**Re: Riverside Center Building 1 (aka 400 West 61st Street), New York, NY
Independent Structural Engineering Review for 80% CDs
GMS Project Number 16360**

**INDEPENDENT STRUCTURAL ENGINEERING 80% CDs
PEER REVIEW**

**RIVERSIDE CENTER BUILDING 1
NEW YORK, NY**

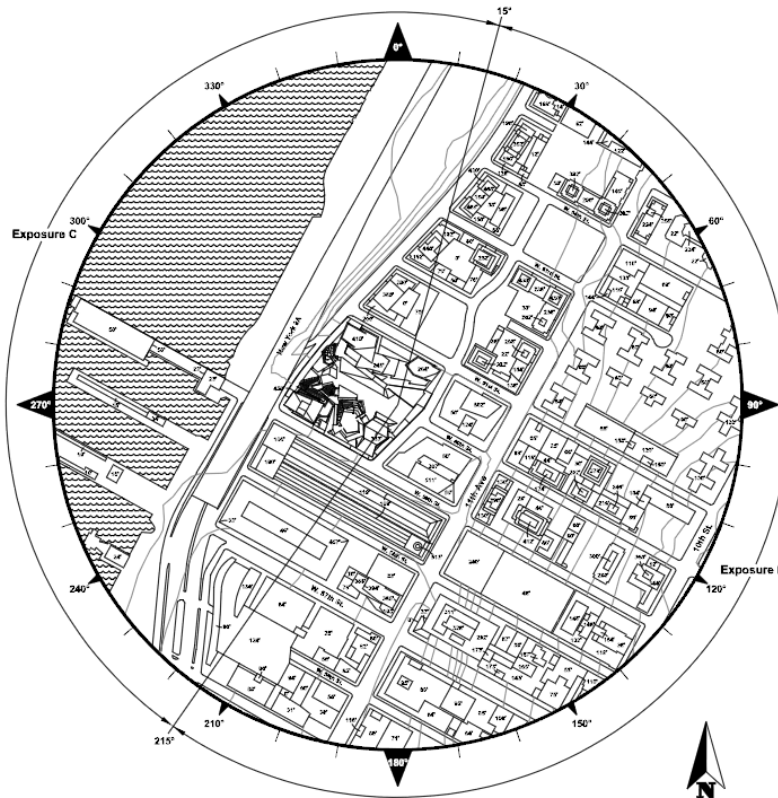
CPP has defined the wind exposure at the site based on the figure below, which is different from the code definition of the exposure categories. The wind loads will be peer reviewed by another wind tunnel consultant for code compliance, and in the event that a consensus is not reached, another wind tunnel

test will be done to confirm that the design wind load meet code. CPP does not anticipate that the design wind load will increase due to the additional test.

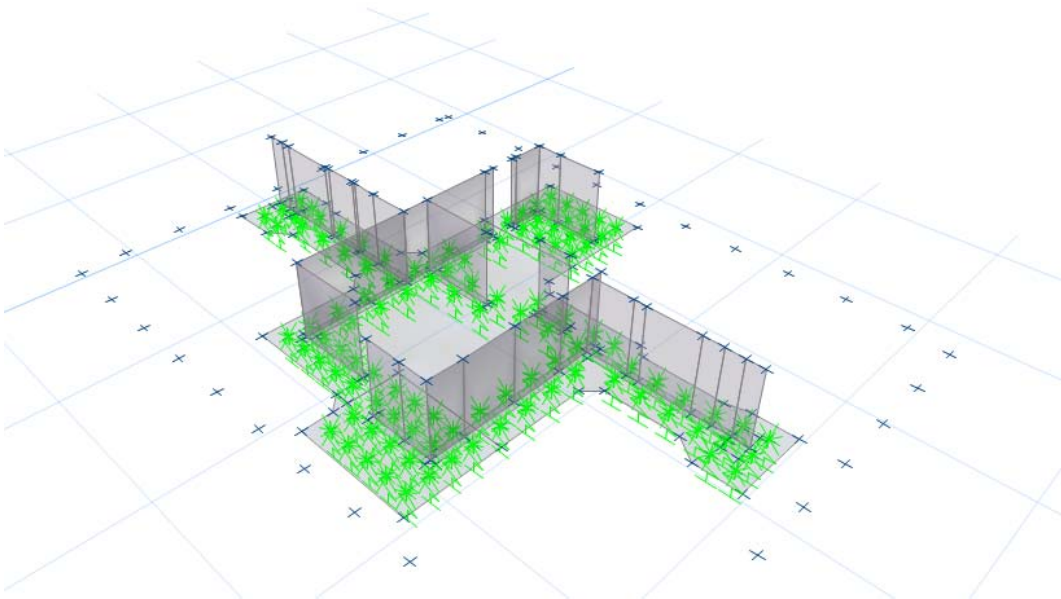
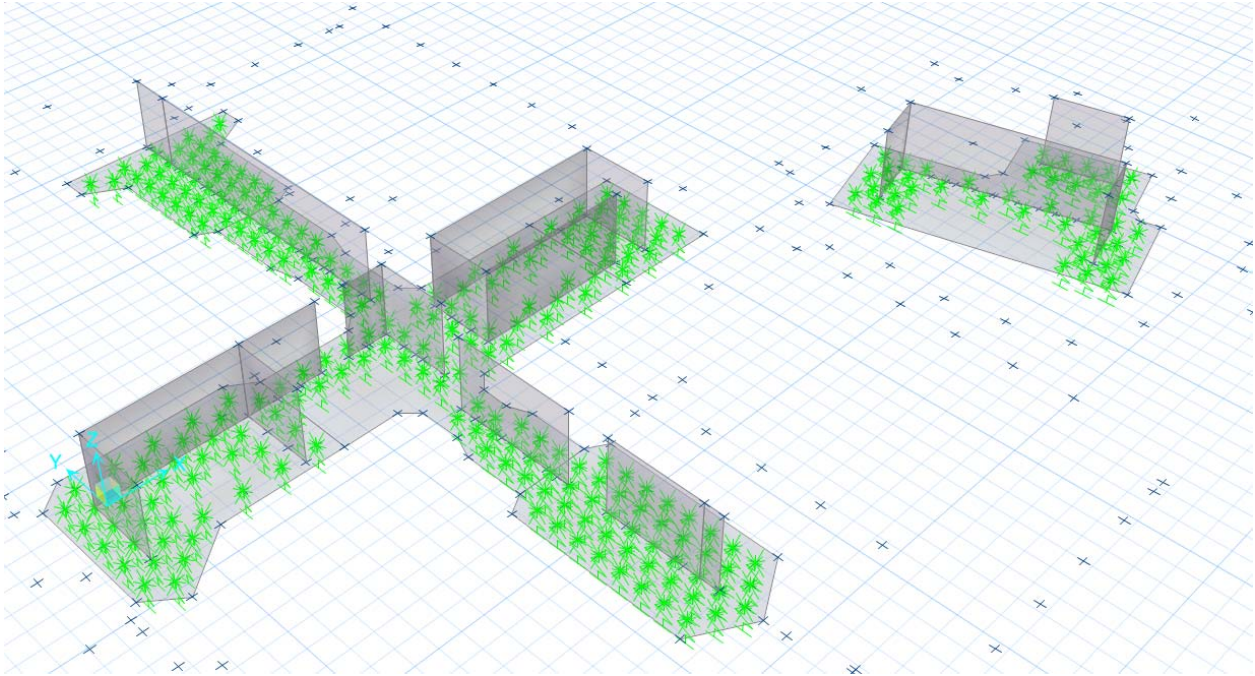
We checked the pile capacity and pile cap reinforcing. Screenshots of our model are provided on the next page.

We have confirmed that the pile cap design is adequate. Top bars are not present at some parts of the pile cap, which may lead to cracking at the top of the pile cap.

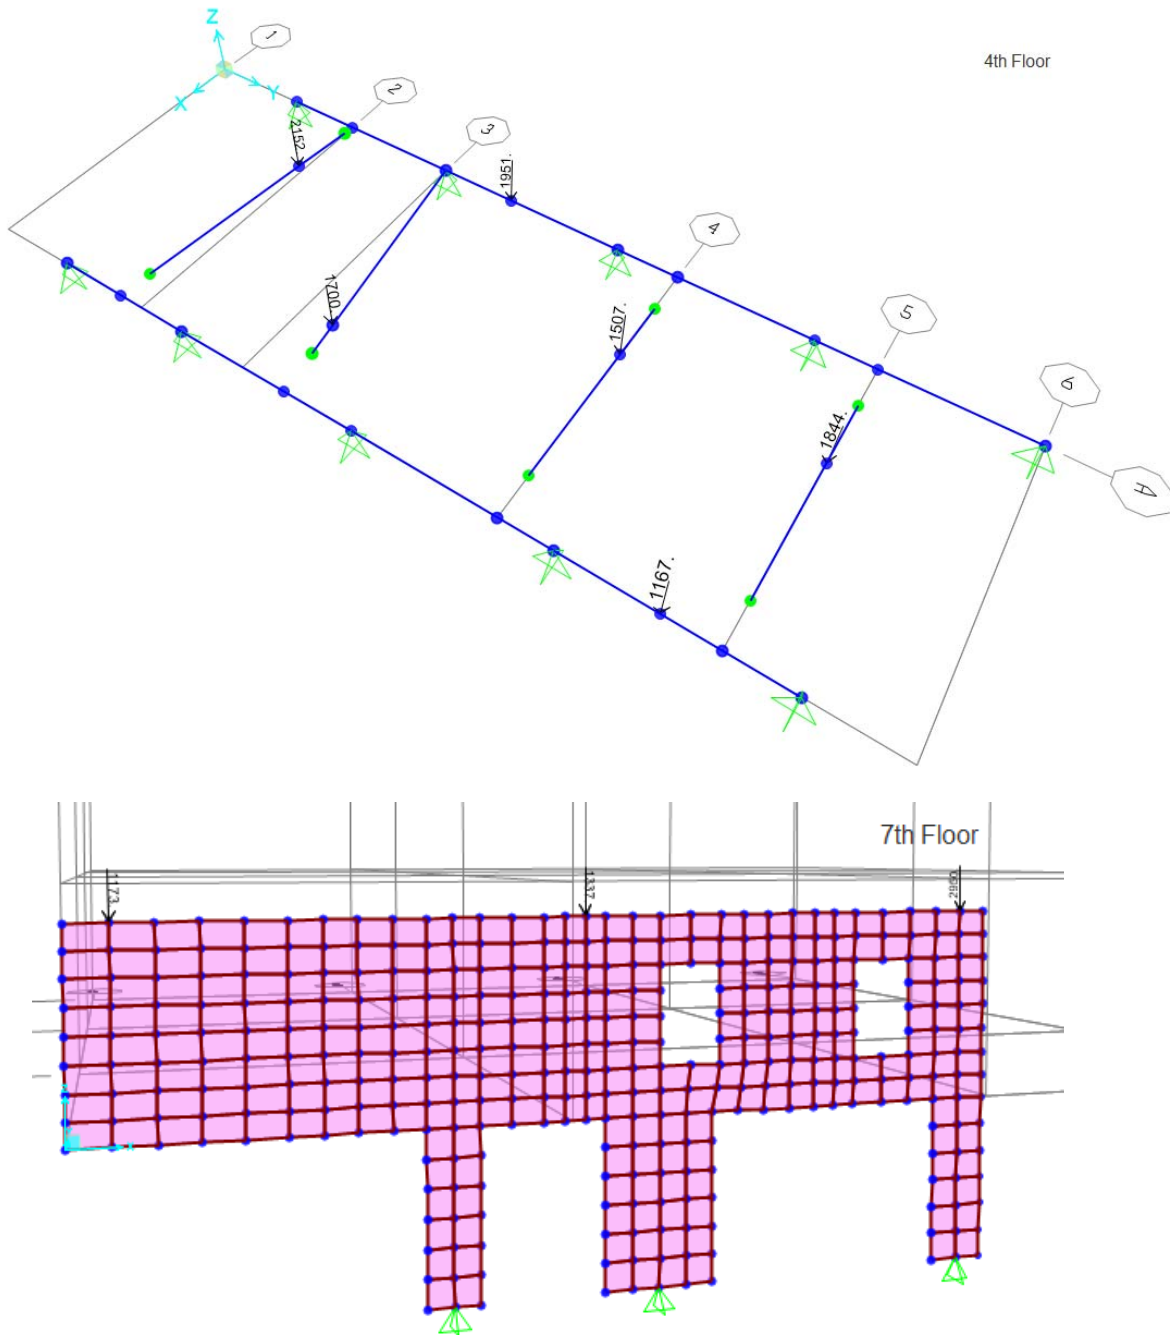
We reviewed the design of cantilevered walking column 1(1A), 2(2A), 3(3A), and 4(4A). We confirmed the load path is adequate at these transfers.

We reviewed the design of two columns (Col. 62 and 218) that are unbraced for more than one floor. We understand that WSP will incorporate our comments and revise the column design.

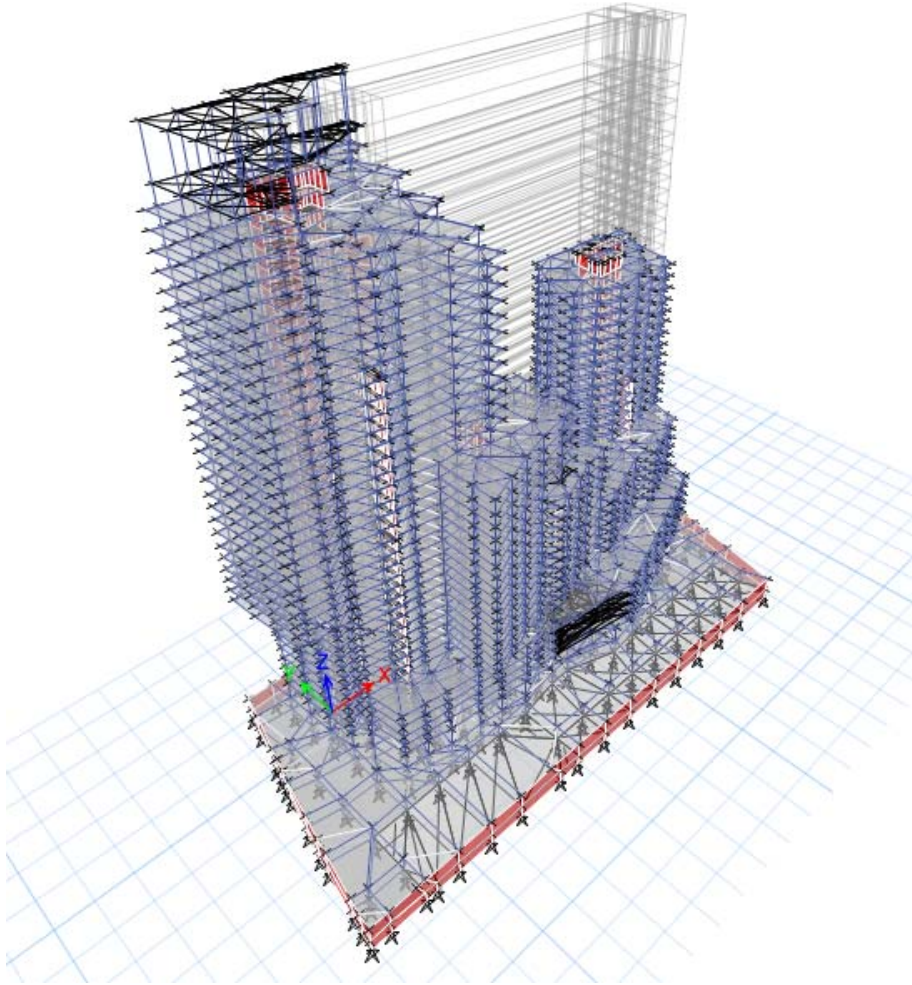
We verified the slab reinforcement and provided WSP our comments. We understand WSP will revise the design as required based on our comments.

Our analysis shows that there may be long term deflections of over 1" some areas of the slab. We understand WSP has done further analysis and reduced the deflections. It should be confirmed that the curtain wall system can accommodate the anticipated slab edge deflections.

Cellar 2 level

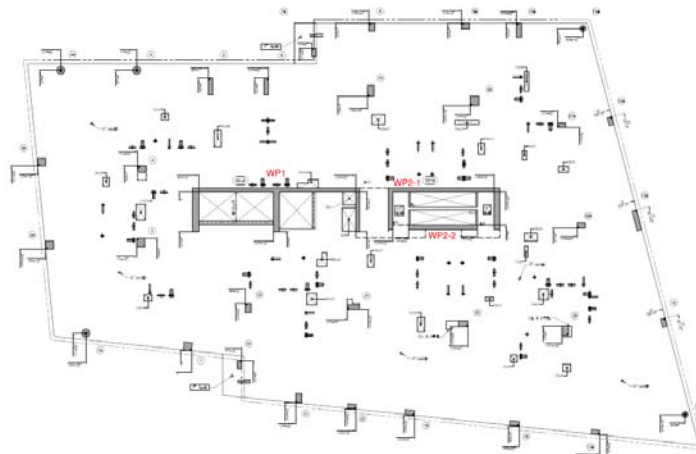
We checked the shear walls at the cellar 2 level and the 31st floor level of West tower for the lateral wind loads from the CPP wind tunnel report dated 02/19/2016. The adequacy of the walls were checked using spColumn. We found that the capacity in the analyzed walls are adequate for the considered loads. We understand that WSP will confirm the adequacy of the design for any updates to the wind load and make revisions as required.

The analyzed walls at cellar2 level and West tower 31st floor level are shown in figures below.
